Addendum No: 7
Date: February 9, 2024
Owner: Northern Health
Stantec # 144320228

Client/Project
Northern Health Authority
UHNBC (University Hospital of Northern BC) -
NAPRA Pharmacy Renovation
1475 Edmonton St, Prince George, BC V2M 1S2

4 PARTIAL EXISTING SINGLE LINE DIAGRAM
E010 N.T.S

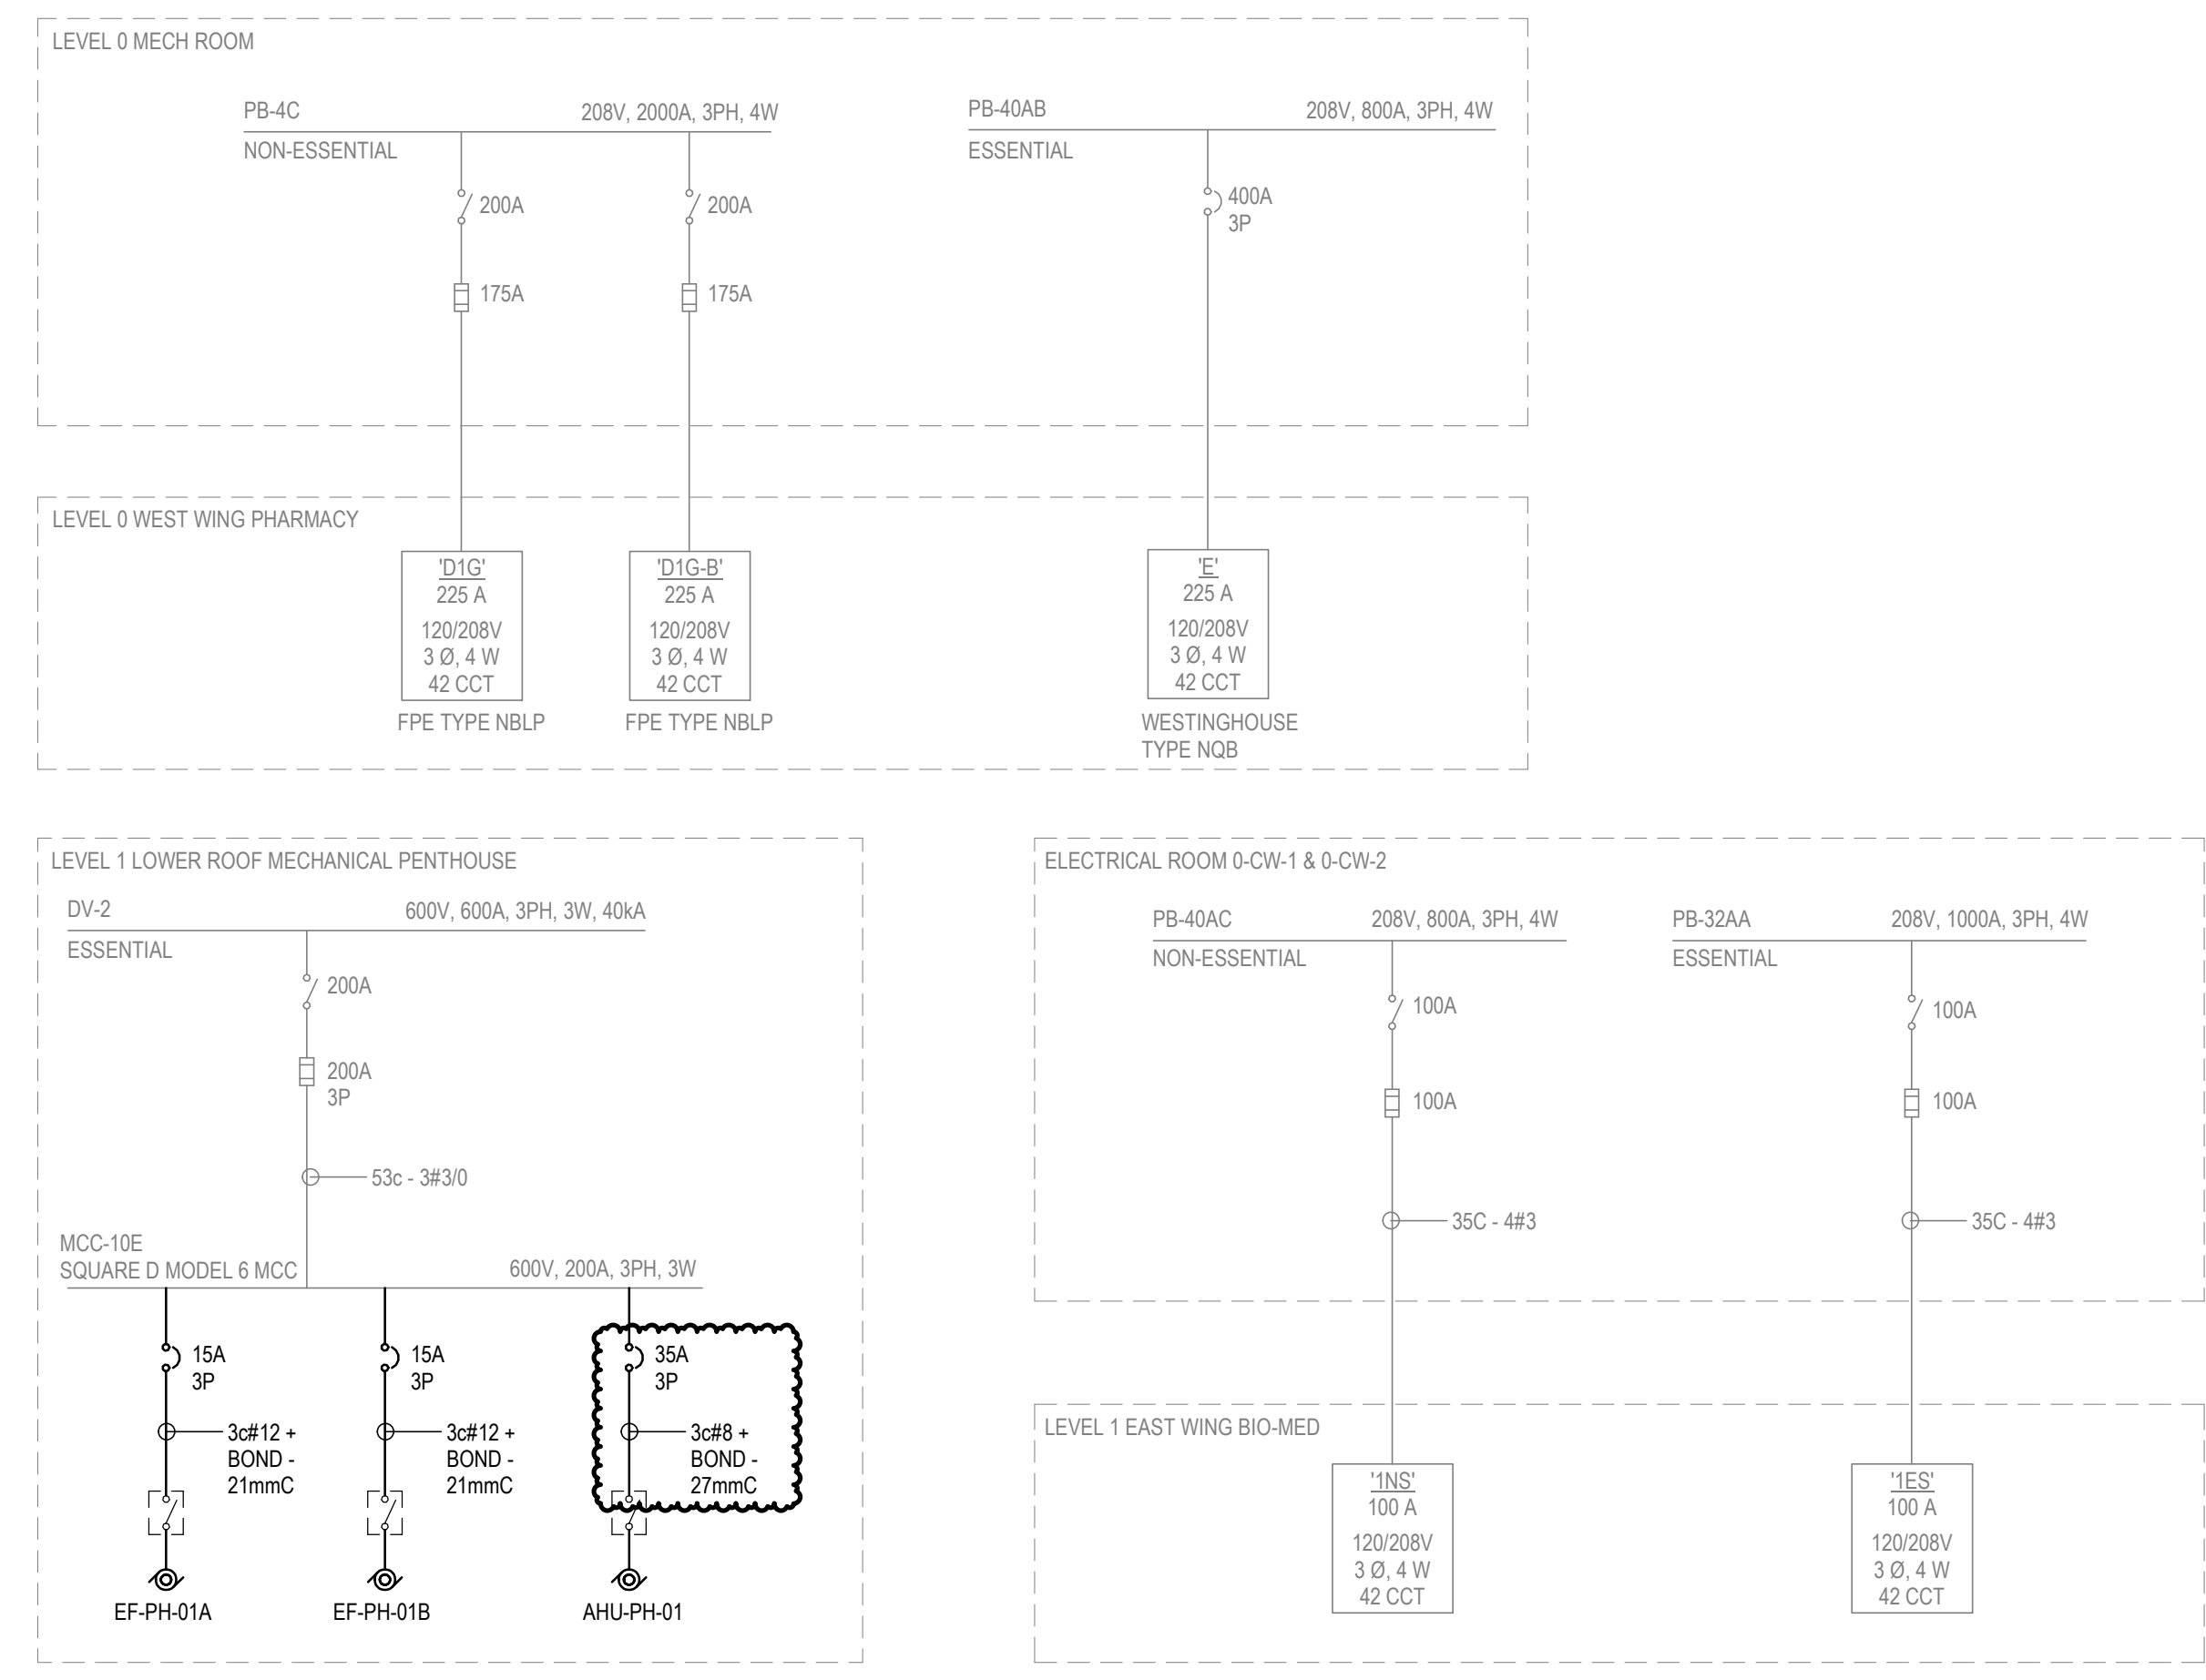
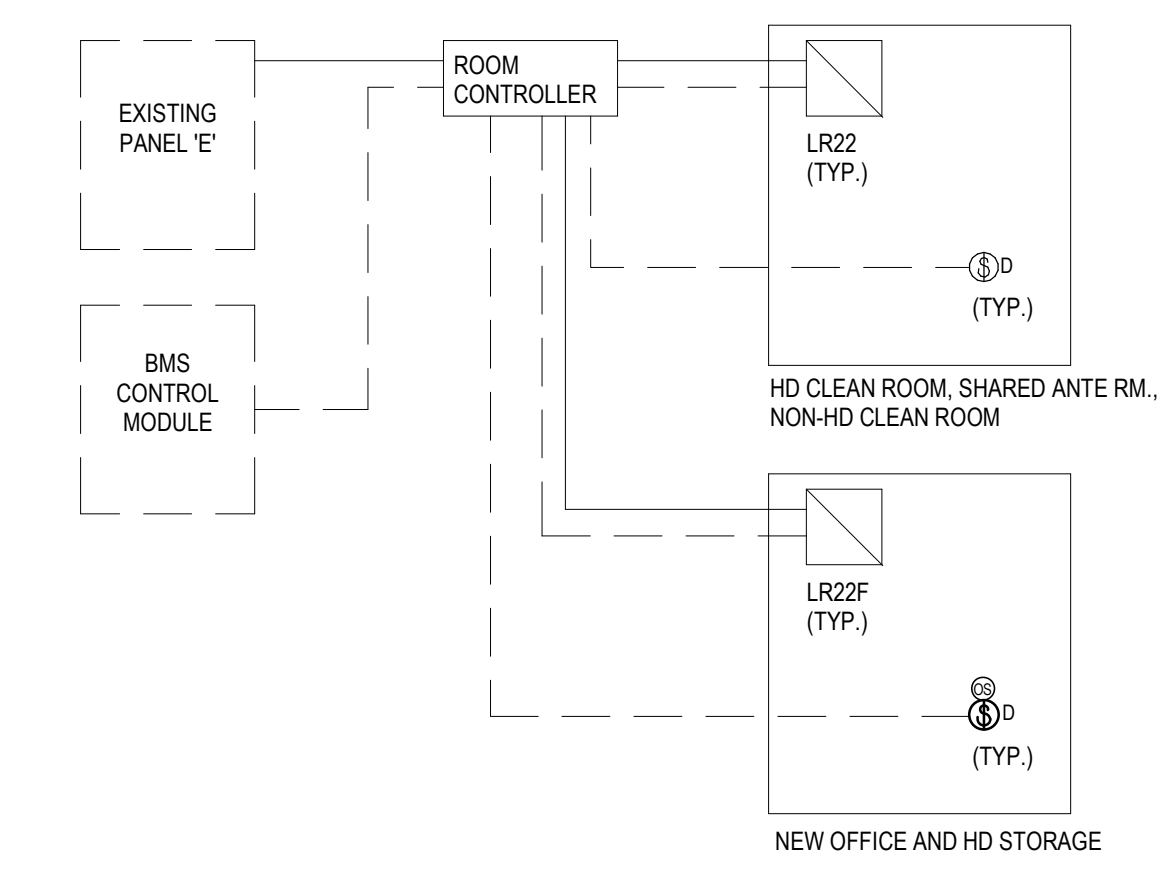
E010 – change breaker for AHU-PH-1, from 25A 3P, to 35A 3P. Change the feeder from 3C#10 AWG Cu to 3C#8 AWG Cu, and the size of the conduit to 27mmC.

Contractor to setup integration to existing BMS (RC Webview), for the lighting controls.

Question: Addendum #3 - #3 Clarification-MCC-10E. Please have electrical engineer contact owner to confirm this breaker space is still available for this project.

Answer: Condition on site shouldn't have changed space still available.
